CHANGE ORDER 229
INSTRUCTION BULLETIN
DEFERRED APPROVALS
ADDENDUM

PROJECT NAME
CHILDREN'S HOSPITAL
OF ORANGE COUNTY
455 S. Main St.
Orange, CA 92668-3874

LOWER LEVEL MECHANICAL
PLAN AREA - S

M3.0S

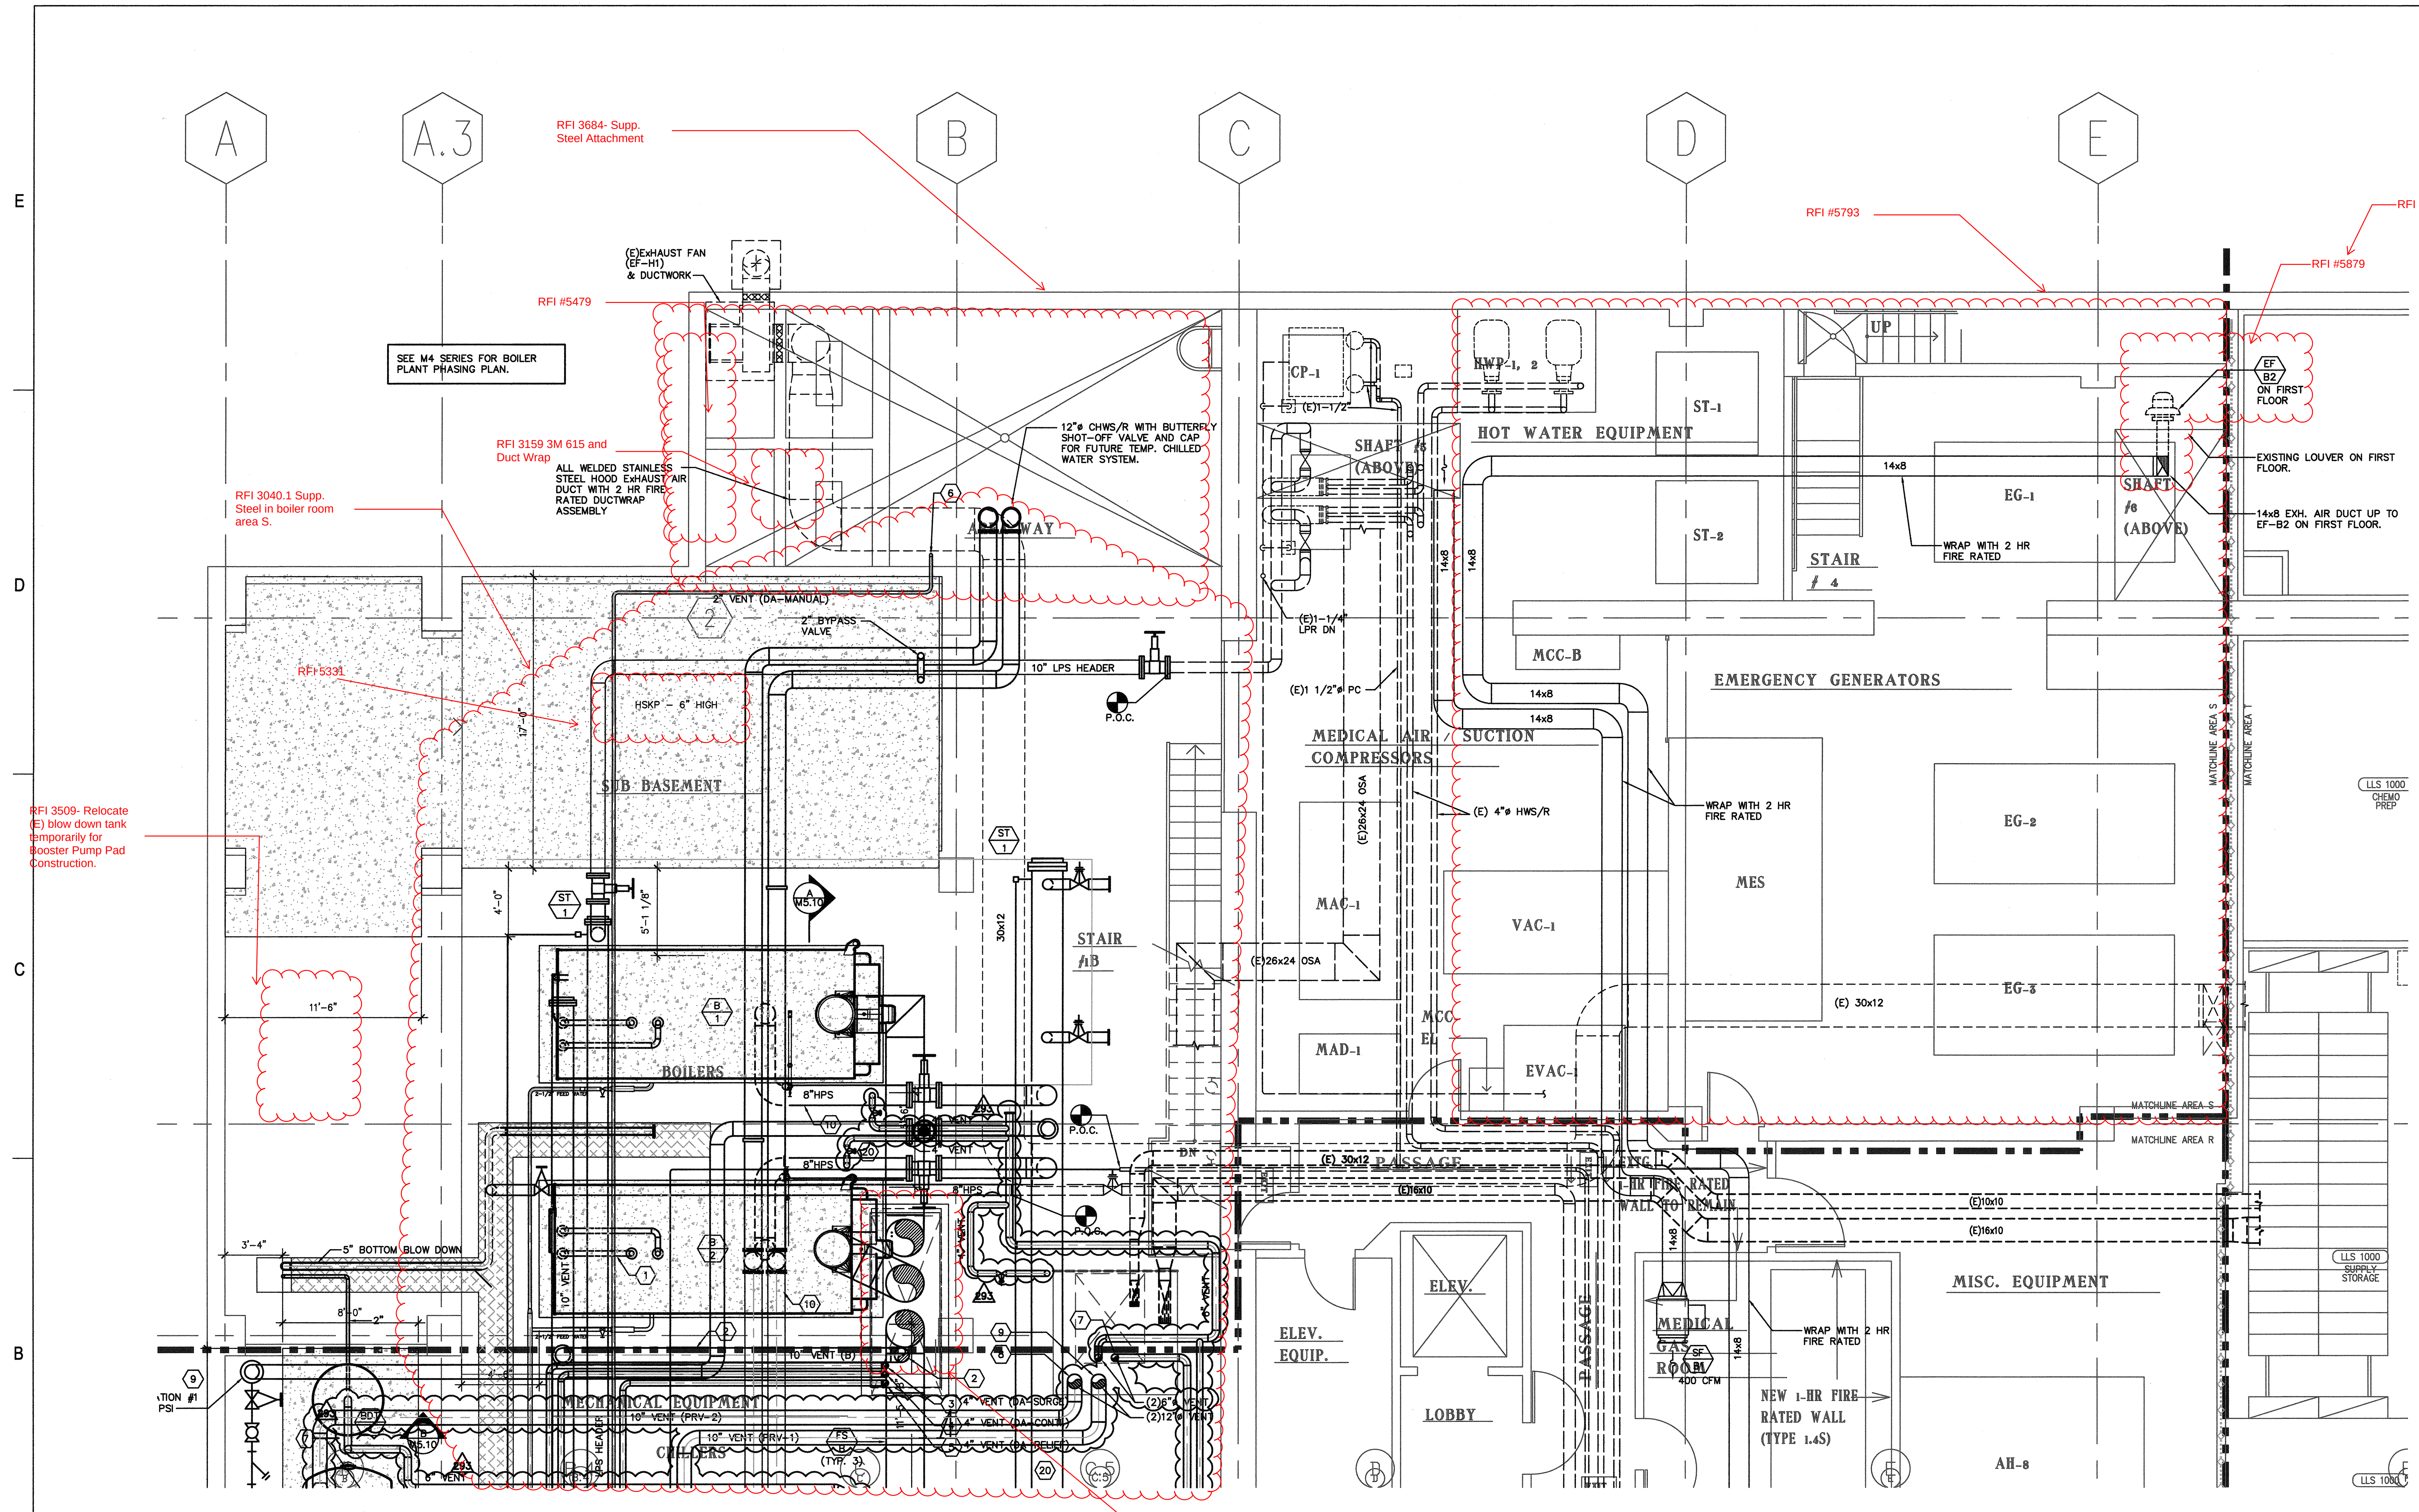
RFI #3631.1
SCAQMD testing ports
installation.
